CHC Puyallup - Cannery

PRCTI20221698 - Revision 2: Distributed Antenna System (DAS) Closet

MECHANICAL
1ST FLOOR PLAN -
DAS SYSTEM CLOSET

ELECTRICAL
1ST FLOOR PLAN -
DAS SYSTEM CLOSET

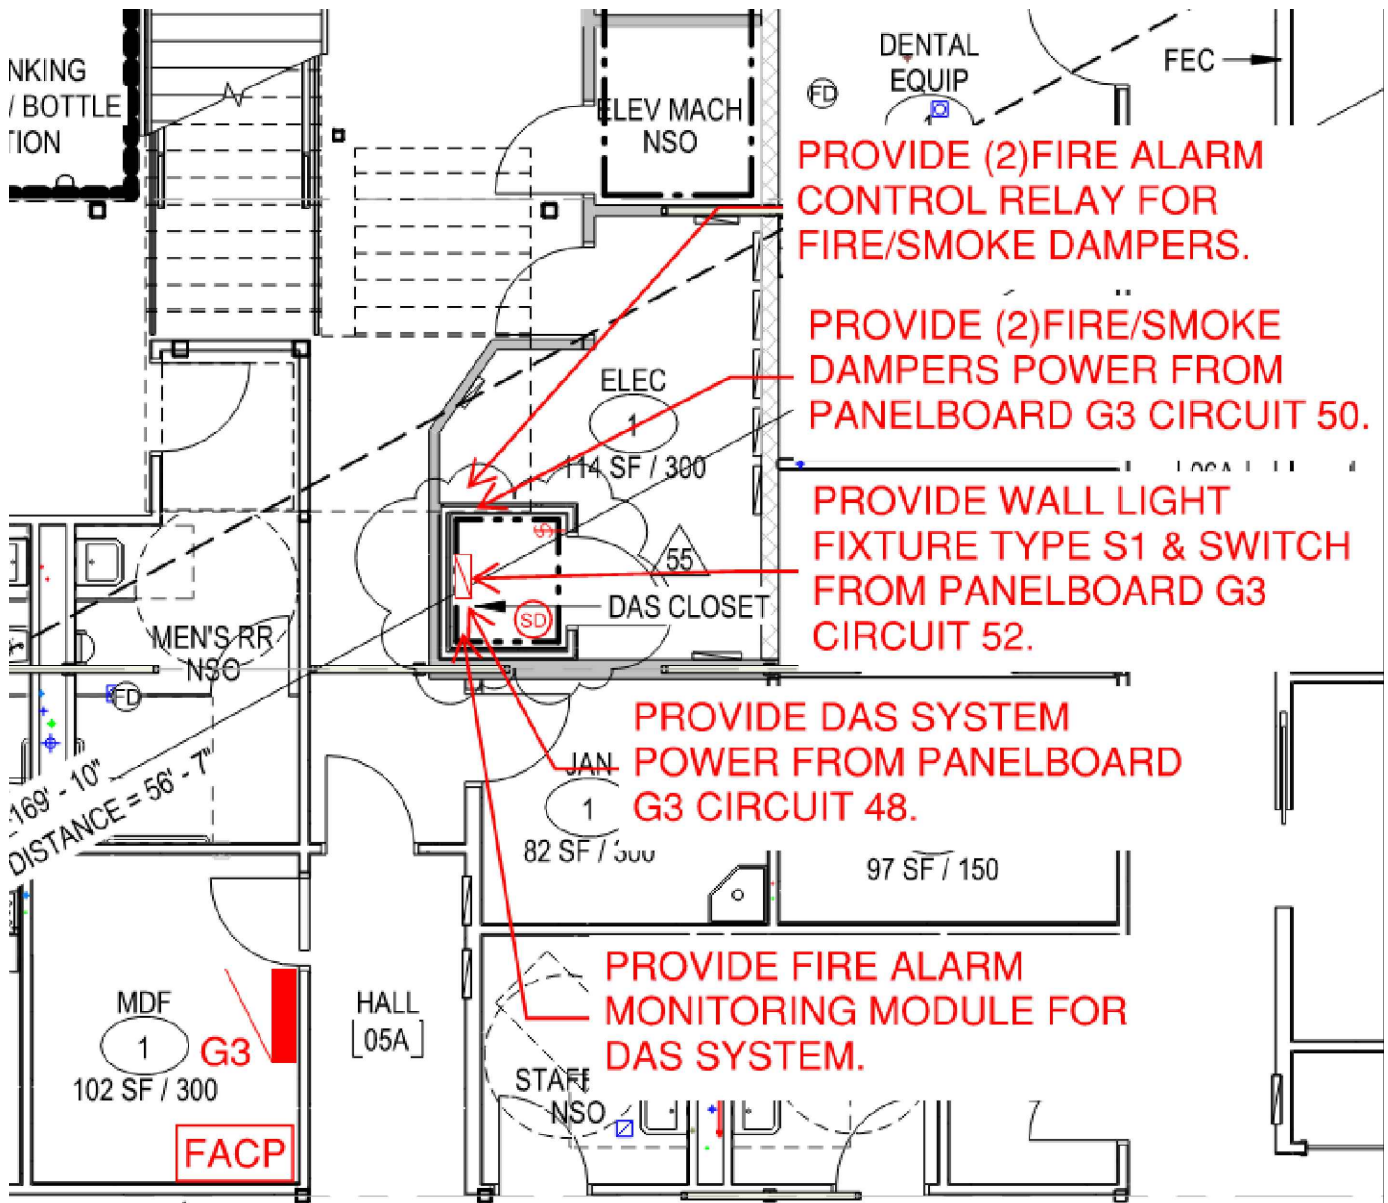
PROVIDE ALL FIRE STOP AS REQUIRED FOR A 2HR RATED ROOM.
